ADDENDUM NO. 01
April 27, 2026

PROJECT: Baton Rouge Terminal Interior Upgrades
 9430 Jackie Cochran Dr.
 Baton Rouge, LA 70811

ARCHITECT: Washer Hill Lipscomb Cabaniss Architecture (LA) LLC, WHLC Architecture
 1744 Oakdale Drive
 Baton Rouge, LA 70810

LEVEL 1 - BAGGAGE CLAIM
NEW RCP

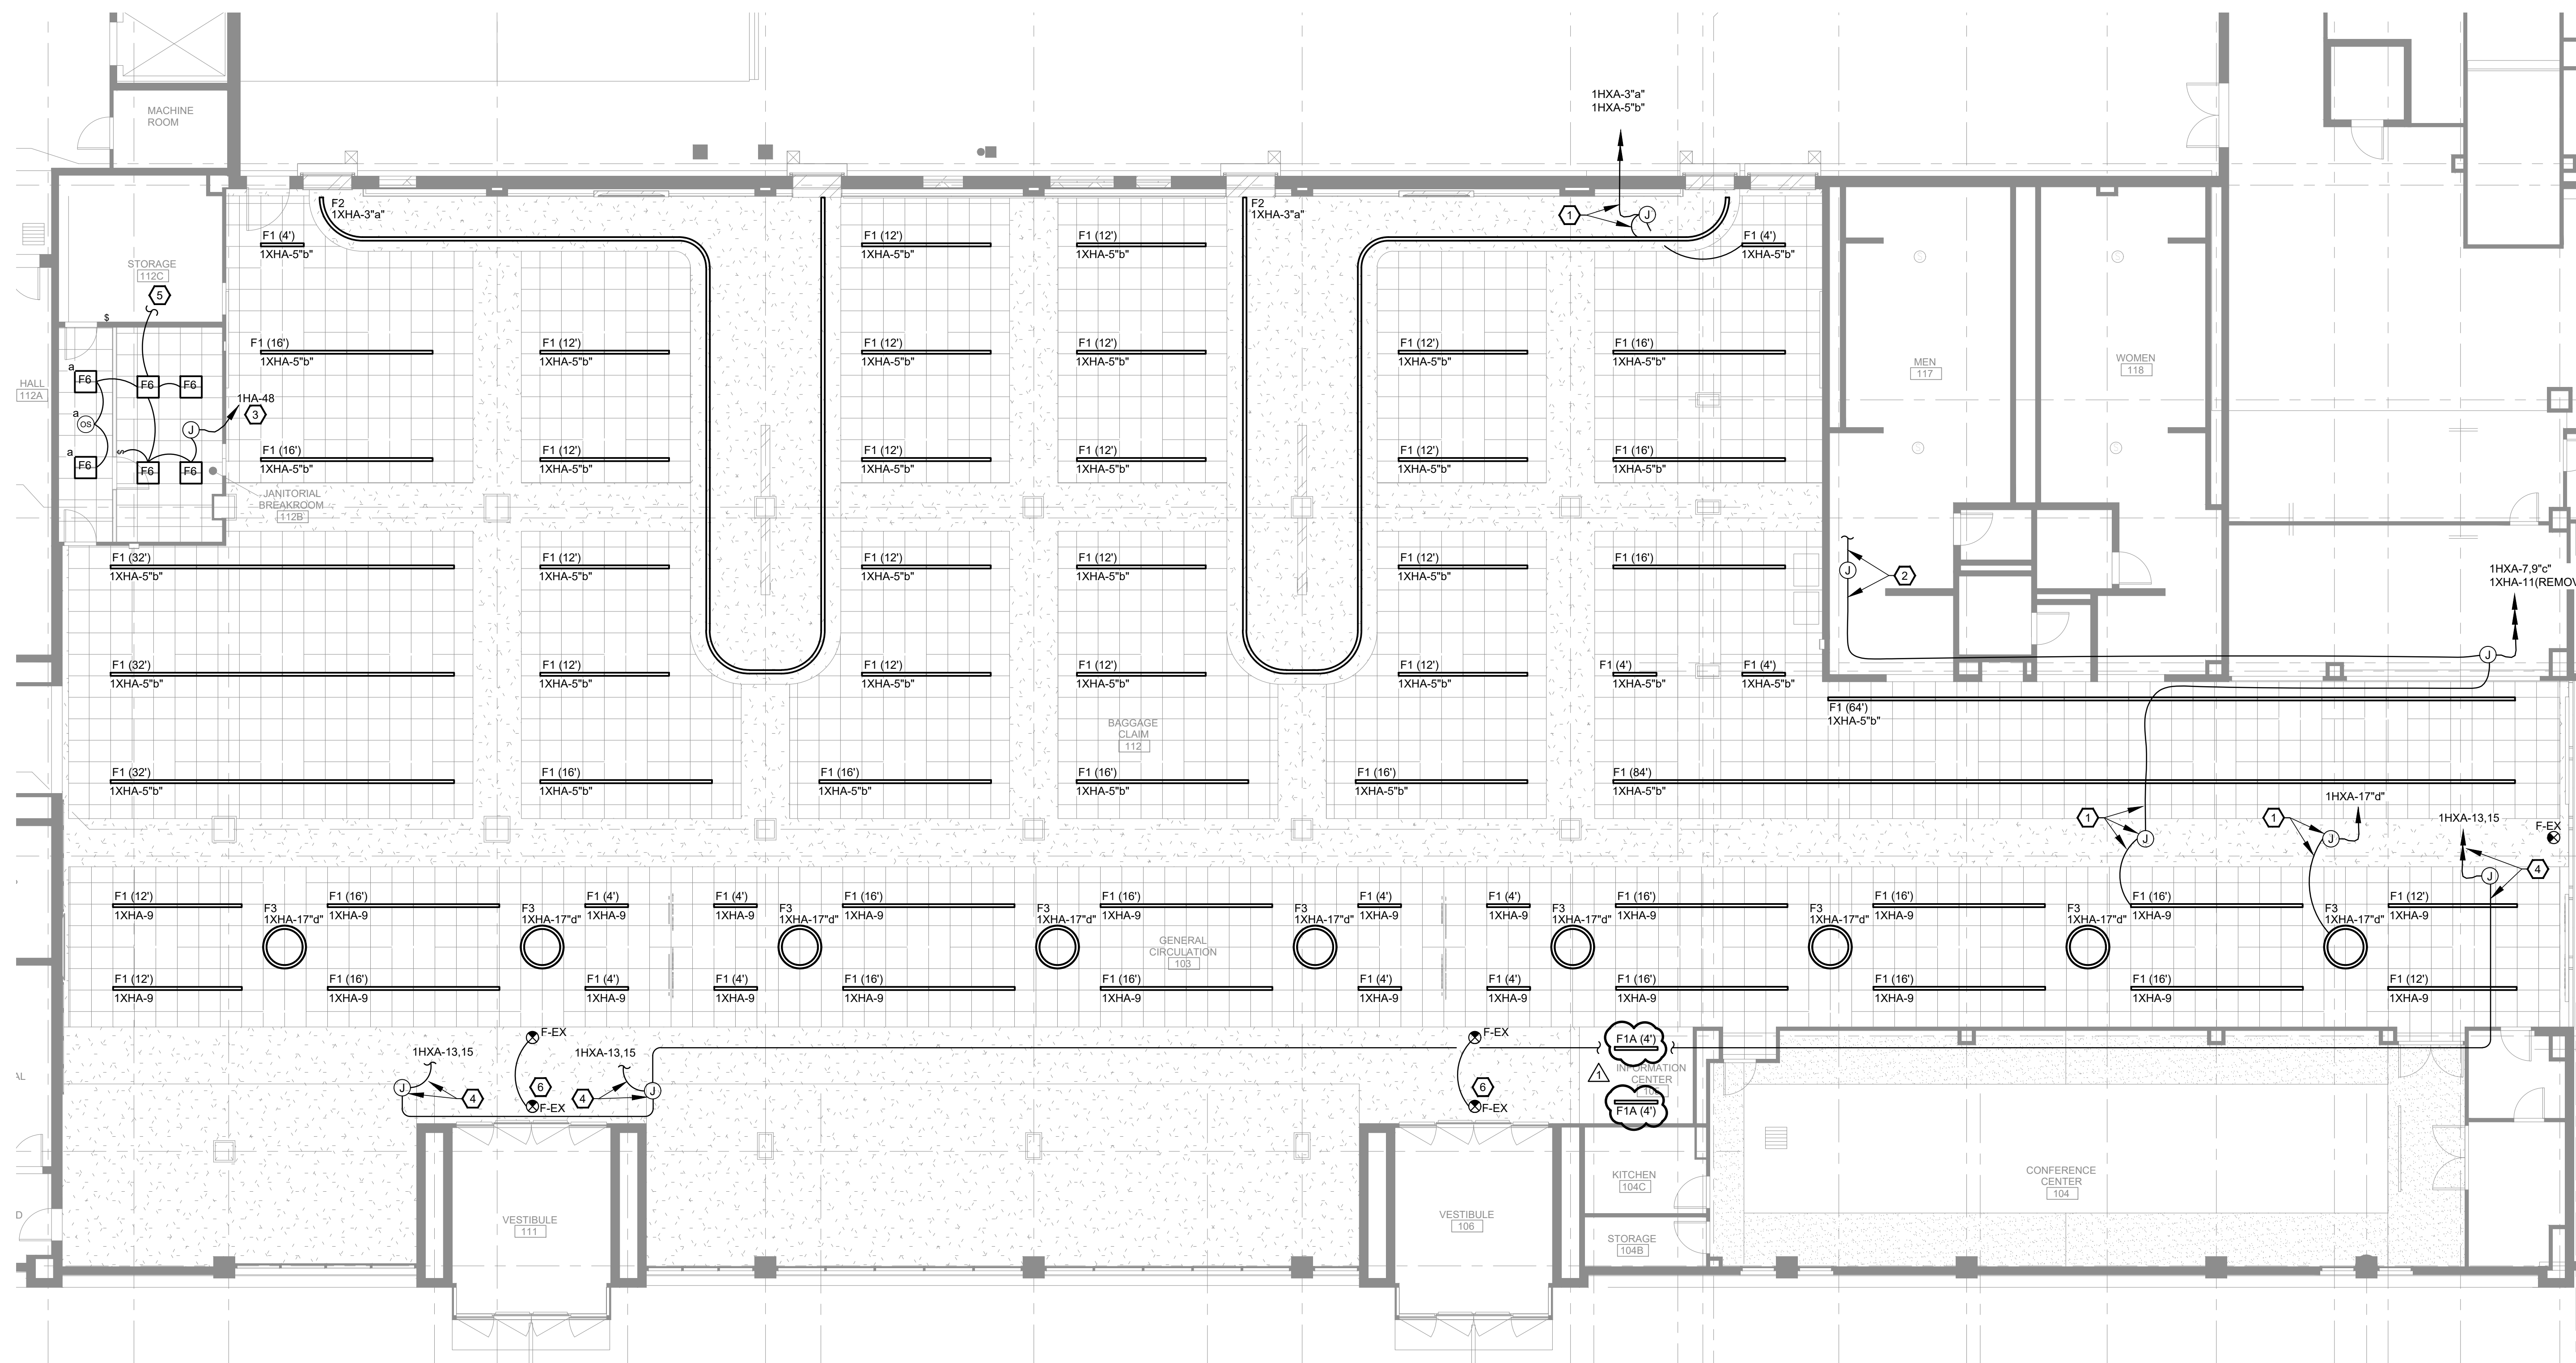
Sheet E14.2: **Revised** the two Type F4 (4') fixtures above INFORMATION CENTER 105 to Type F1A (4') fixtures. **1 page** (24"x36")

E14.2

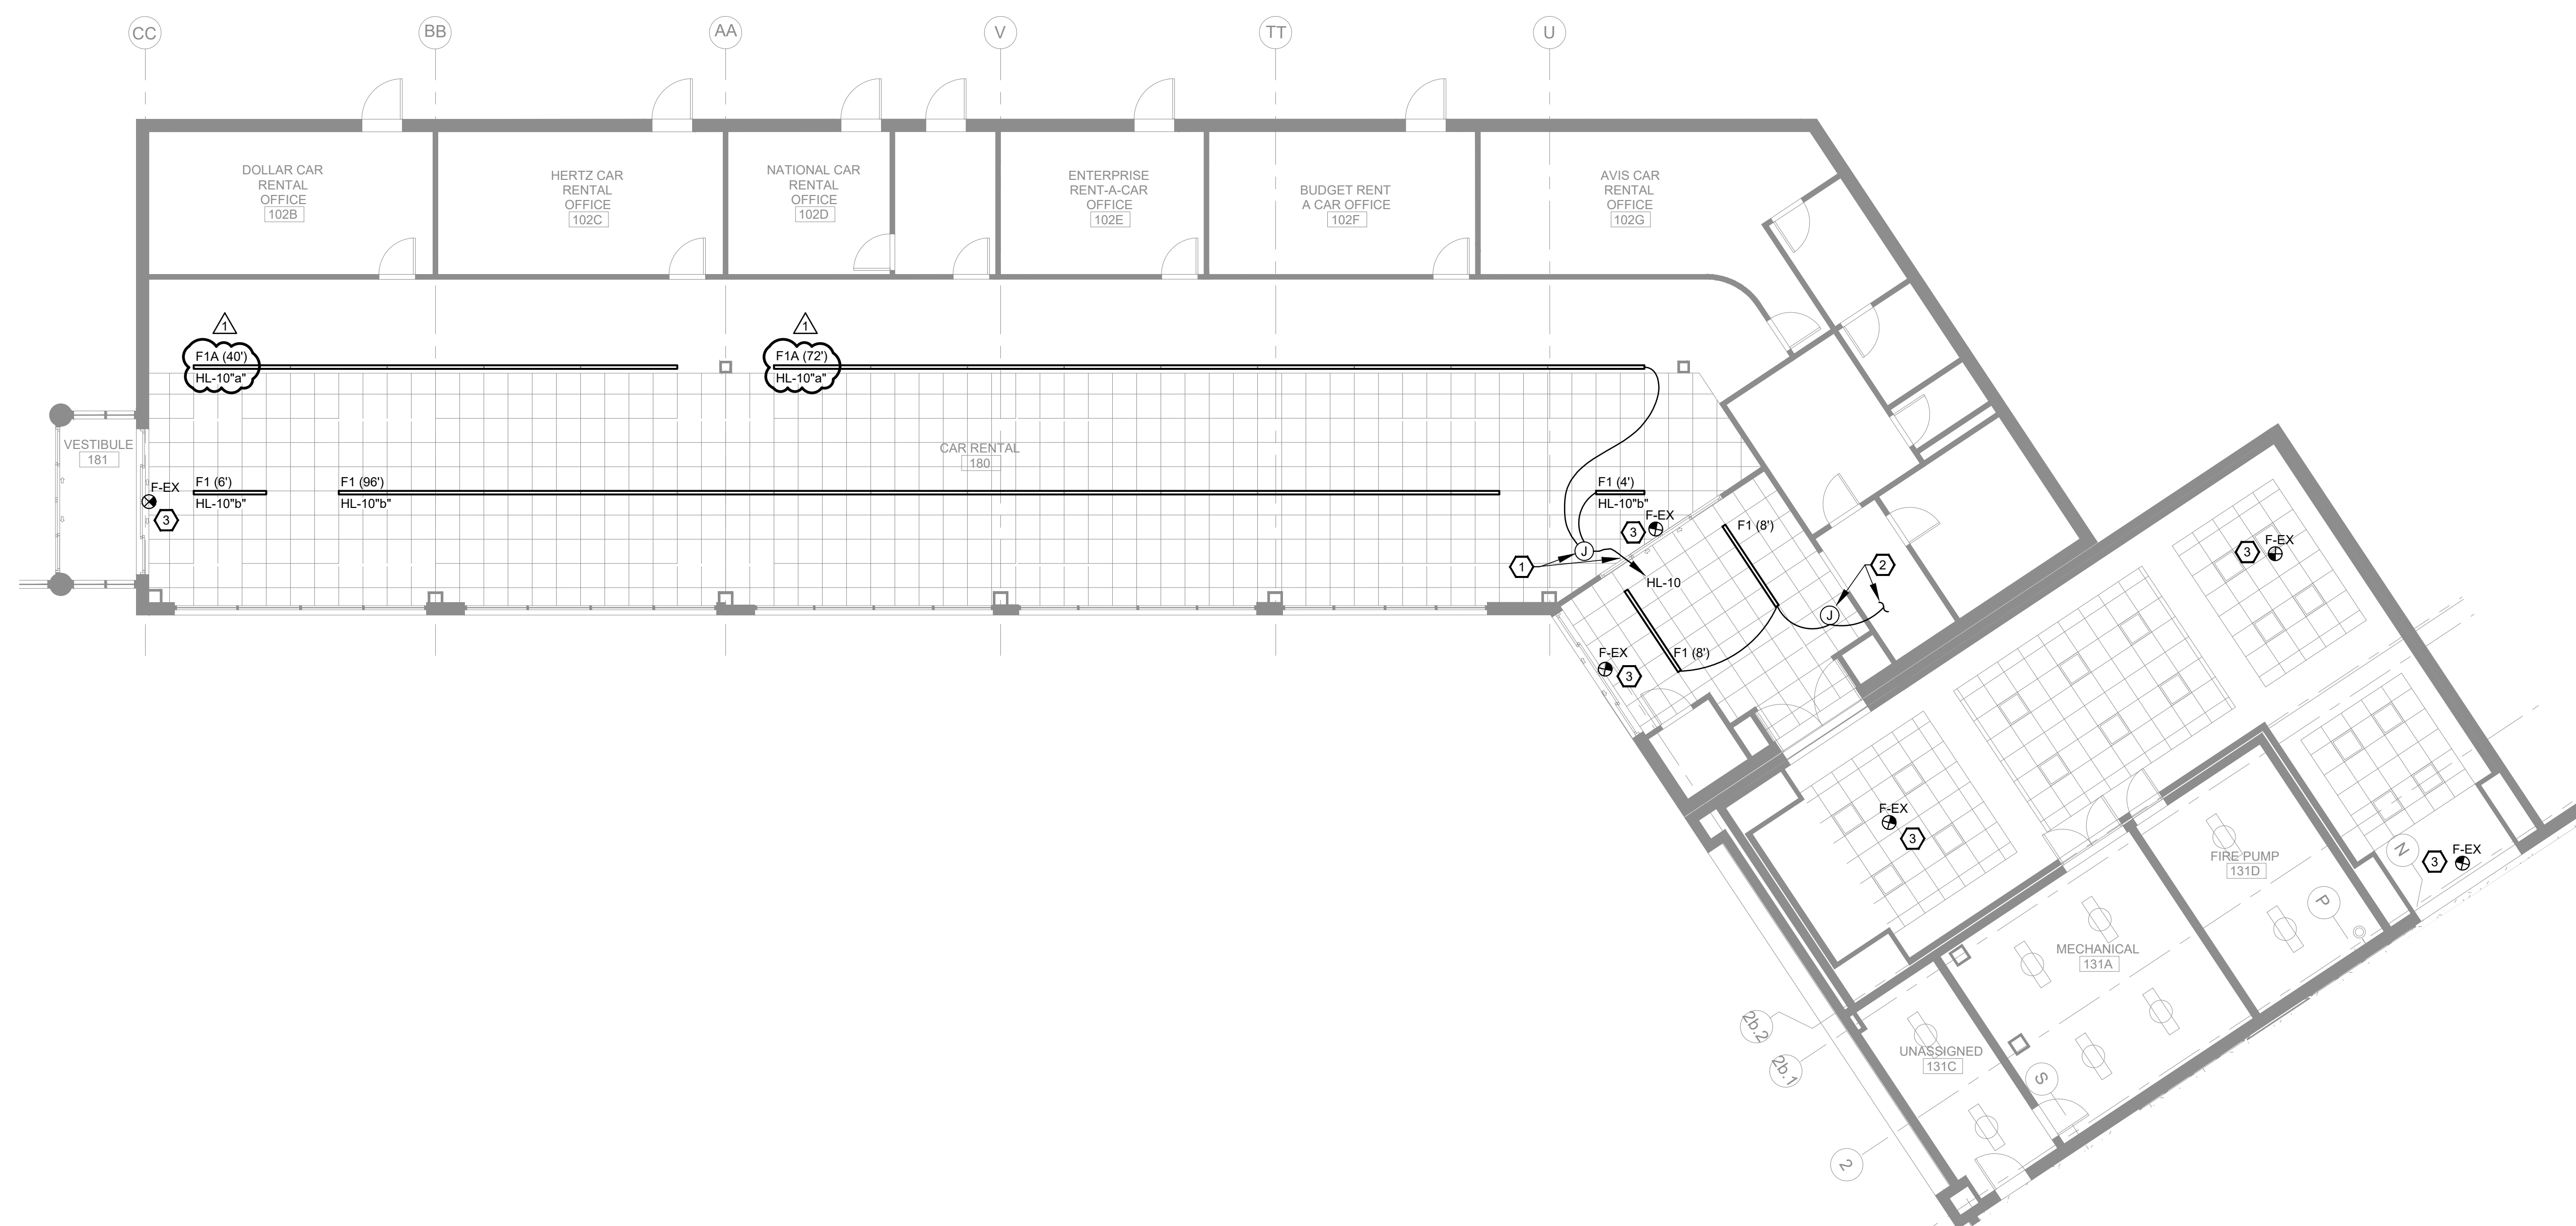
Sheet E14.3: **Revised** the Type F1 (40') and F1 (72') fixtures above CAR RENTAL 180 to Type F1A (40') and F1A (72') fixtures respectively. **1 page** (24"x36")
